Hazen *Technical Memorandum*

May 22, 2026

Bangor-Keyport Force Main Evaluation

Figure 2-1. Site 16 Culvert Crossing

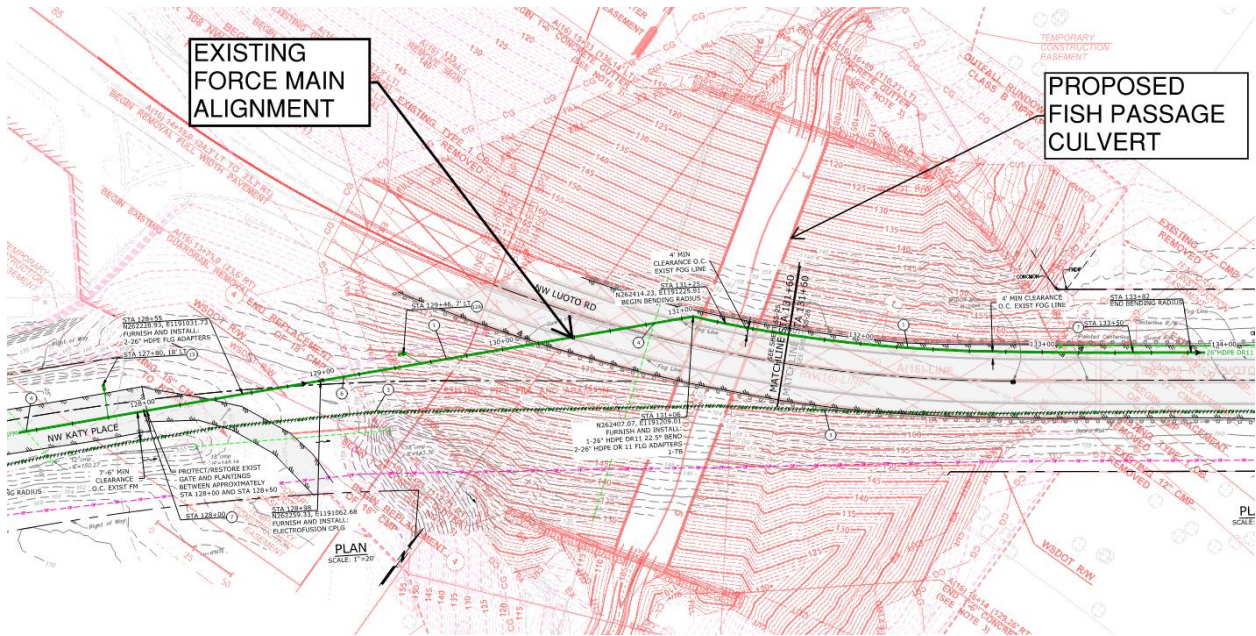
- Site 16 includes an approximately 100-foot proposed vertical deflection to pass beneath the proposed fish passage culvert
- Site 17 includes an approximately 20-foot proposed vertical deflection to pass beneath the fish passage culvert.

The proposed profile modifications introduce deep inverted siphon-like conditions, with low points prone to increased sediment accumulation, and steep downhill and uphill segments promoting high flow velocities that can result in hydraulic jumps, air entrainment, and off gassing. A preliminary hydraulic profile comparison was performed between the existing and proposed modified conditions. This analysis utilized available system data and assumed that hydraulic behavior of the force main replaced in 2023 is comparable to historical observations of the previous force main operation Figure 2-1 and Figure 2-2 show the proposed WSDOT culvert crossings overlaid with the force main record drawings.

The proposed fish passage culvert modifications would deepen the existing low points within the force main by approximately 80 feet at Site 16 and approximately 20 feet at Site 17. Because both locations are already situated at local hydraulic low points within the system, some degree of grit accumulation would be expected under existing conditions. However, the increased depth and revised vertical profile are expected to significantly increase the potential for sediment deposition and long-term accumulation.

The proposed crossing at Site 16 incorporates what will be the deepest and steepest change in vertical alignment within the system. This configuration lends itself to increased system operational uncertainties, poor efficiencies, and long-term reliability challenges. Because of the issues and challenges with heavy grit accumulation experienced within the existing system, and their exacerbation by installing a new piping segment in a deep, inaccessible alignment below the proposed culvert, designing a bypass to also serve as a permanent relocation solution would need to be strongly considered. A bypass system is required for any scenario considered to construct the culvert, therefore installing the new pipeline in as close to the same location, and more importantly depth to the existing line will avoid intensifying the grit accumulation challenges. This approach maintains accessibility for crews to address problems that may necessitate quick access to the pipeline. There is a high risk the pipeline will become clogged and pigging or flushing will prove to be ineffective, requiring a bypass system and constructing a new pipeline segment above the proposed culvert. This will further impede traffic while the road is removed to address.

1. Site 16 Crossing:
 - a. Increase in grit and solids accumulation.
 - b. Insufficient driving head for pigging and cleaning.
 - c. Vacuum truck lift limitations.
 - d. Increase in gas and air entrainment and accumulation beyond design criteria.
 - e. Deep subsurface and below structure accessibility.
 - f. Increased potential for system surge and pressure fluctuations.
 - g. Potential for line failure and washout of crossing.
 - h. Inspection equipment access and entrapment.
2. Site 17:
 - a. Increase in gas and air entrainment and accumulation beyond design criteria.
 - b. Increase in grit and solids accumulation within the specific pipe segment.
 - c. Insufficient driving head for pigging and cleaning.
 - d. Potential for line failure and washout of crossing.
 - e. Deep subsurface and below structure challenges and accessibility.

1. Site 16:
 - a. Maintain a bypass system during culvert construction and replace the force main as construction is progressed to the backfill phases to return the piping to its existing

alignment, avoiding the significant vertical drop and the associated challenges. A phased construction approach may help reduce bypass duration.

- b. Reconfigure the horizontal piping alignment around this location and maintain pipe elevations to closely match existing conditions.
2. Site 17:
- a. Incorporate the use of a pipe bridge along the downstream side of the proposed culvert to maintain existing pipe vertical alignment.
 - b. Incorporate the use of pipe hangers or supports along the downstream culvert headwall to suspend the pipe along its existing vertical alignment.
 - c. Reconfigure the horizontal piping alignment around this location and maintain pipe elevations to closely match existing conditions.

Figure 2-2. Site 17 Culvert Crossing

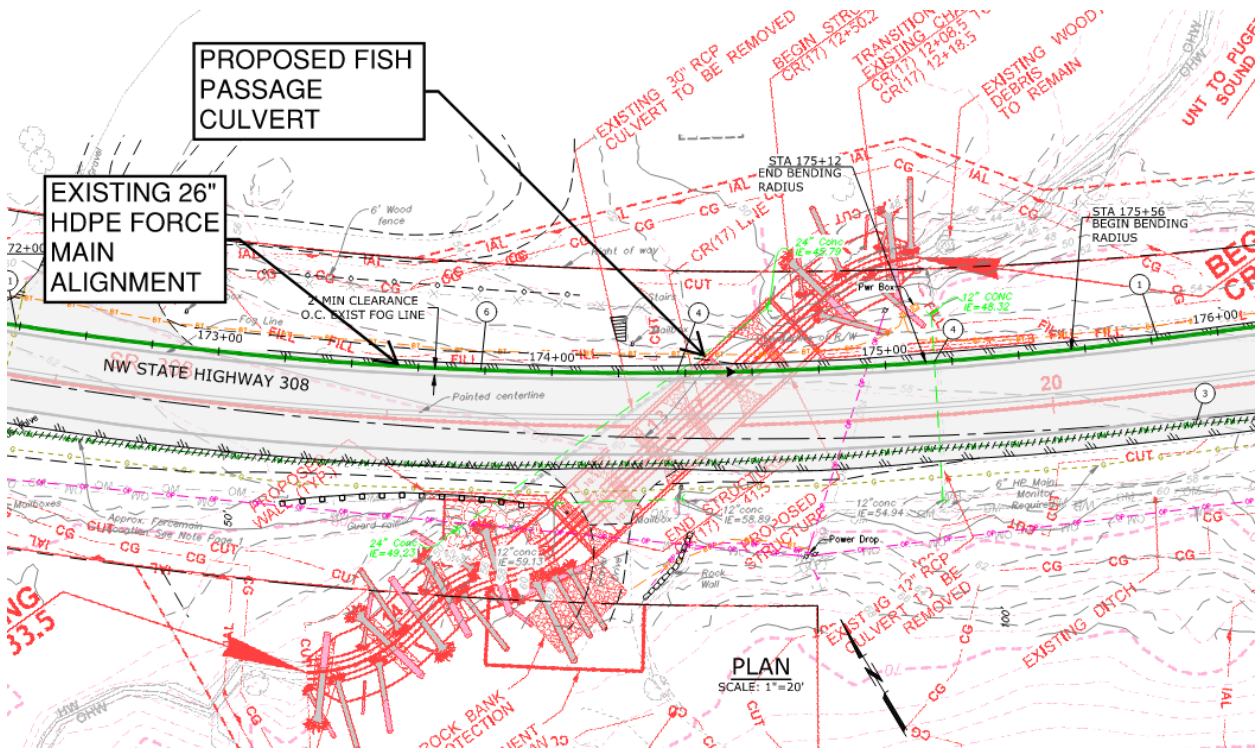
The proposed crossing at Site 17 results in a vertical alignment shift like those within the existing alignment. While it is not anticipated that the revised alignment will result in a significant increase in grit accumulation and maintenance challenges, it will increase within the specific segment. Additionally, consideration should be given to address the increased air entrainment and off gassing that will result.

Figure 3-1: Modeled Hydraulic Profile of Proposed Force Main Profile

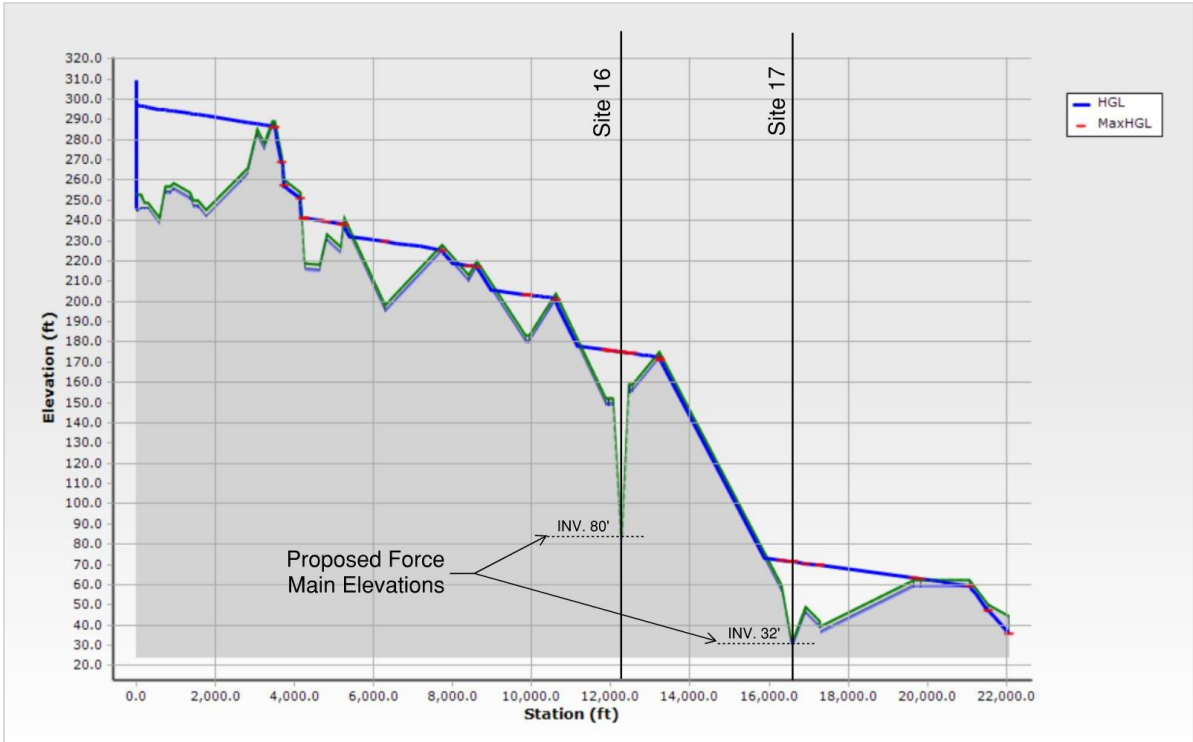
Figure 3-2 and Figure 3-3 show the modeled hydraulic and velocity profiles, respectively of the existing pipeline with the proposed modifications. Like BHC’s 2019 Technical Memorandum, which was discussed in Section 1, the model predicts that the force main is pressurized until the manhole located at a high point in the system at Node PJ-32. After this location, the force main transitions to gravity flow, fluctuating between partially full to full flow conditions depending on the slope. Both culvert sites are located at relatively low points within their respective alignments and hydraulically do not appear to impact the rest of the system’s operation. The proposed modifications are not expected to create operational issues for the existing LS-17 pumps. However, major operational considerations, including cleaning and pigging, are discussed further in this technical memorandum (TM). The velocities identified at each of the proposed fish passage culvert locations are approximately 3.4 feet per second (fps) at peak flow conditions, as shown in Figure 3-2. Velocities in the surrounding system are expected to be much higher and can range between 10 to 15 fps depending on the respective slopes.

Figure 3-2: Modeled Velocity Profile of Proposed Force Main Profile (LS-17 @ 3,600 gpm)

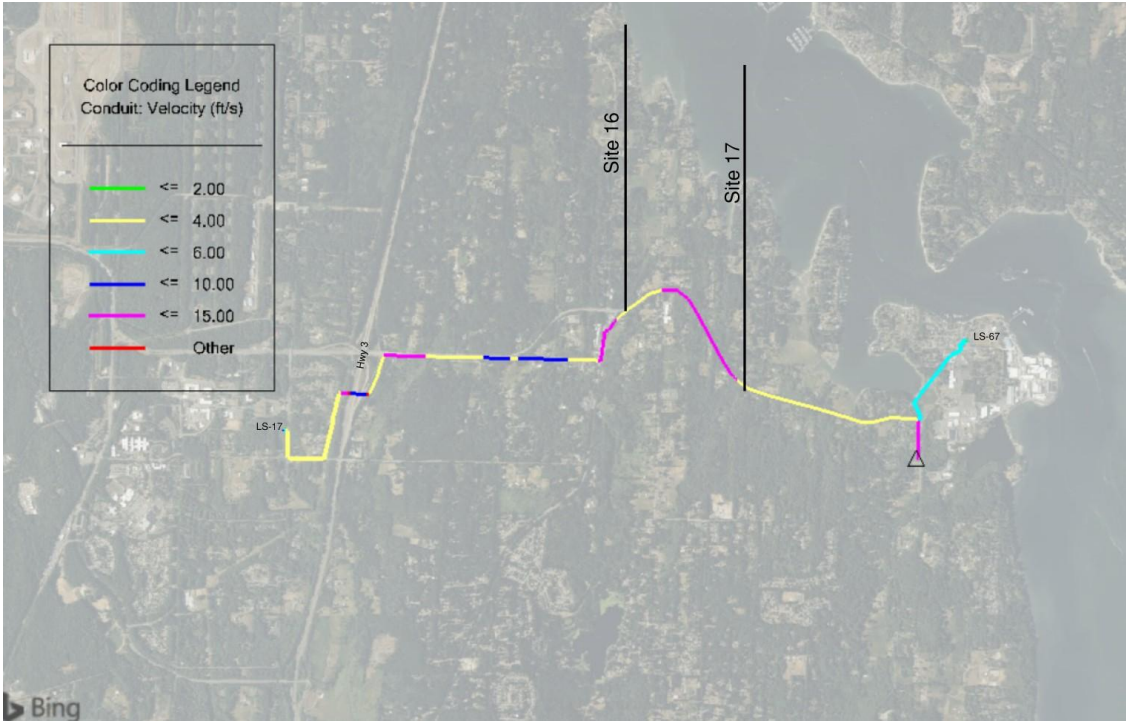
While typically velocities greater than 3 fps are sufficient to suspend and maintain solids in suspension, this velocity is the highest identified at the proposed crossings. The modeled scenario accounts for the maximum system operating condition in which LS-17 and LS-67 are both pumping into the same force main. If flow from LS-17 is reduced or the pumps are off, the velocities in this section reduce below 3.4 fps and will reach 0 fps during times both lift stations are offline.

Figure 3-3: Modeled Velocity Profile of Proposed Force Main Profile (LS-17 @ 250 gpm)

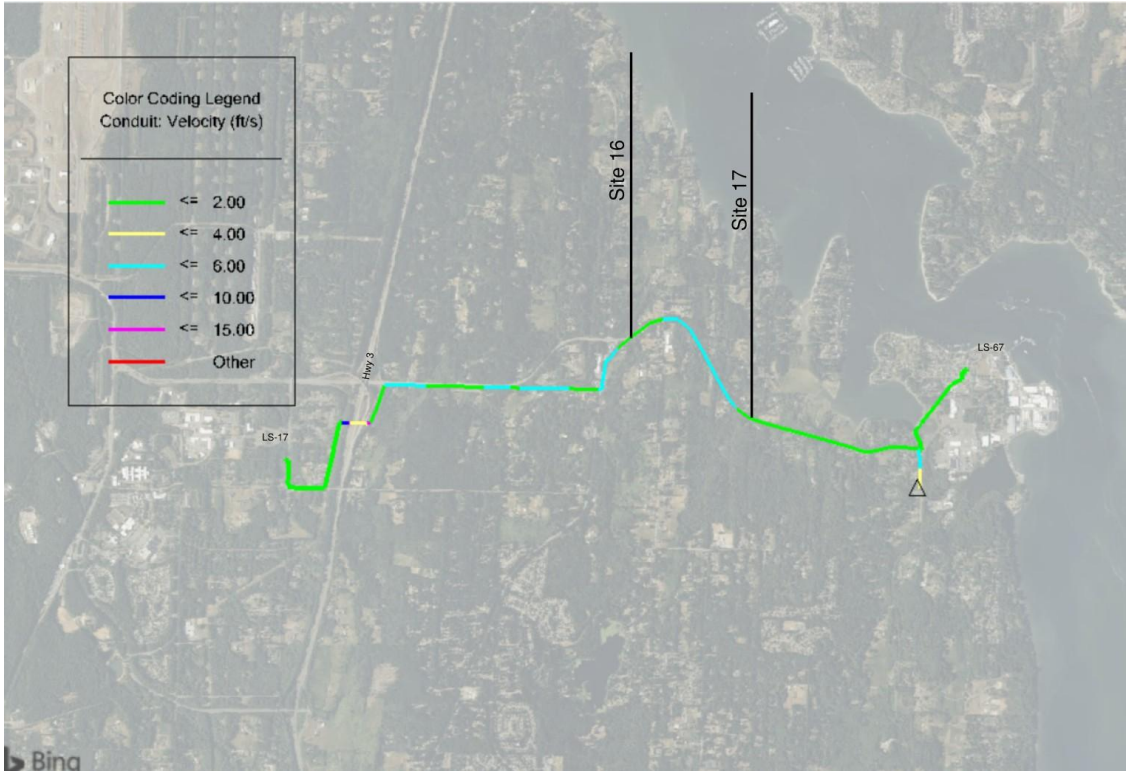
The flow meter data from the County indicated average flows of 250 gpm from the years 2021 to 2023. These flows are significantly lower than maximum operating conditions. When the model was re-run, assuming 250 gpm is pumped out of LS-17, the results indicated a velocity of 0.23 fps through the proposed modified sections, as shown in Figure 3-3. The resulting velocities below the maximum operating conditions listed in Table 3-1 will result in an increase in grit accumulation that has proven to be difficult to displace. Additionally, fluctuating flow regimes between full and partially full pipe flow

and abrupt changes in velocities due to varying slopes, even at maximum operating conditions, increase the uncertainty of predictable hydraulic behavior.

Figure 4-5. On/Off Cycling Grit Accumulation in Fish Passages

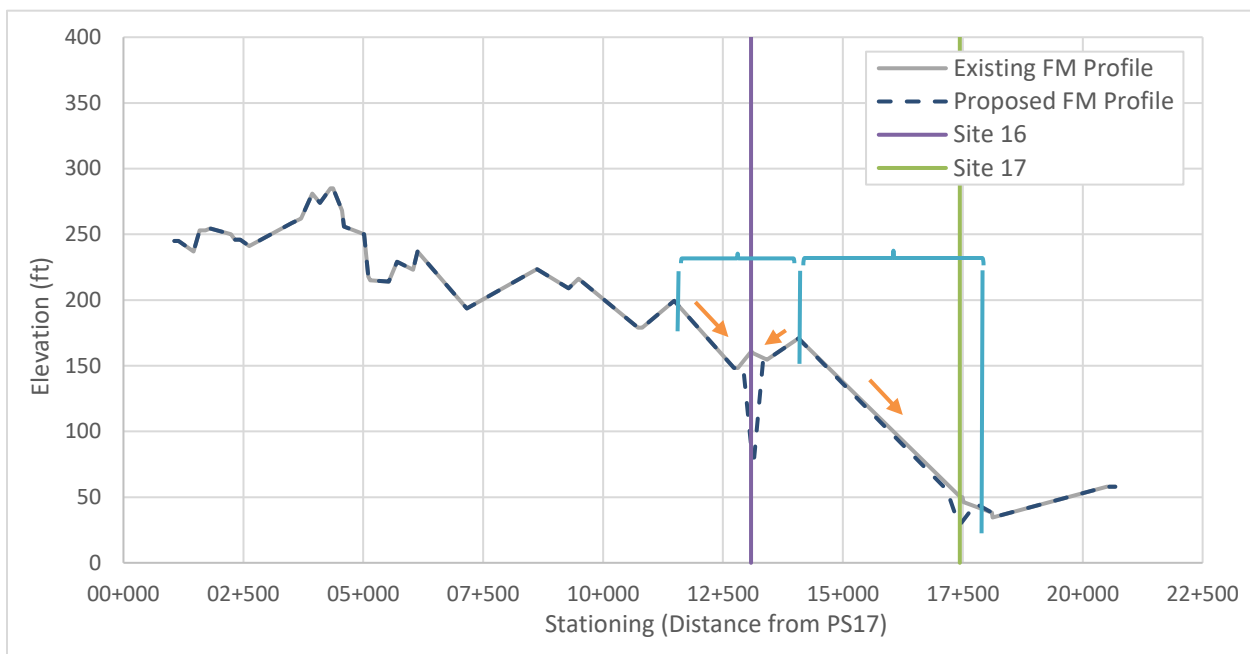
In addition, increased pump cycling may unintentionally exacerbate grit accumulation at the proposed fish passage locations during no-flow conditions. Because both crossings are located at low points in the system, solids suspended within adjacent upstream and downstream pipeline segments would tend to settle toward these locations whenever pumps are offline. Based on the estimated settling velocities summarized in Table 4-1, most grit particles will settle from suspension within approximately 10 minutes after flow is stopped.

As a result, grit deposition will be exacerbated in the immediate sections beneath the culverts as solids from longer segments of the force main between adjacent local high points will progressively migrate and accumulate within the proposed low sections. For both crossings, the contributing pipeline length extends several thousand feet, as illustrated in Figure 4-5.
